# Access Compliance Report

### (Curb Ramps)

Intersection ID: 6925	Main Street: VILLAGE_TOWNHOUSE_DR	Cross Street: GRIERS_GROVE_RD	Location: NE
ADA ID: 05C0EE170D94	Ramp Type: Perp	Initial Pass/Fail: Fail	Overall Compliance: No
Severity Score: 37.5			
Codes/Mitigation Info/Possible Solution		Field Measurements/Component Compliance

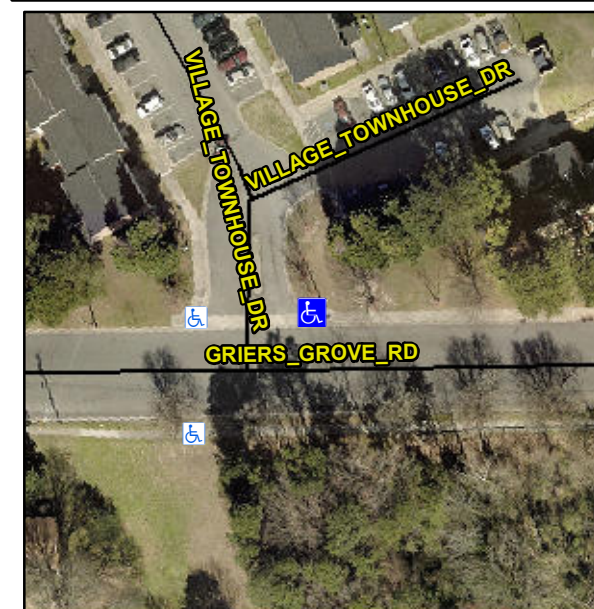
**Not Found, R304.2.2, R304.5.3**

Compliance	Description	Data	Compliance	Description	Data
N/A	Ramp Length (in)	60.0	No	Ramp Slope (%)	12.0
Yes	Ramp Width (in)	70.0	No	Ramp XSlope (%)	5.2
N/A	Flare Type LT	N/A	N/A	Flare Type RT	N/A
N/A	Flare Slope LT (%)	N/A	N/A	Flare Slope RT (%)	N/A
N/A	Flare Traversable LT?	N/A	N/A	Flare Traversable RT?	N/A
N/A	Landing Length (in)	N/A	N/A	DWS Provided?	N/A
N/A	Landing Width (in)	N/A	N/A	DWS Contrast?	N/A
N/A	Landing Slope (%)	N/A	N/A	DWS Length (in)	N/A
N/A	Landing X Slope (%)	N/A	N/A	DWS Full Width?	N/A
N/A	Landing Curb? (Y/N)	N/A	N/A	DWS Offset (in)	N/A
N/A	Shared Landing?	N/A			
N/A	Gutter Ponding?	N/A	N/A	Gutter Slope (%)	N/A
N/A	Gutter Lip Ht (in)	N/A	N/A	Gutter X Slope (%)	N/A
N/A	Painted X Walk1?	No	N/A	Painted X Walk2?	N/A
	X Walk 1 Direction	To W		X Walk 2 Direction	N/A
N/A	X Walk 1 Width (in)	N/A	N/A	X Walk 2 Width (in)	N/A
	X Walk 1 Slope (%)	2.6		X Walk 2 Slope (%)	N/A
	X Walk 1 X Slope (%)	11.6		X Walk 2 X Slope (%)	N/A

**Remove & Replace Entire Ramp.**
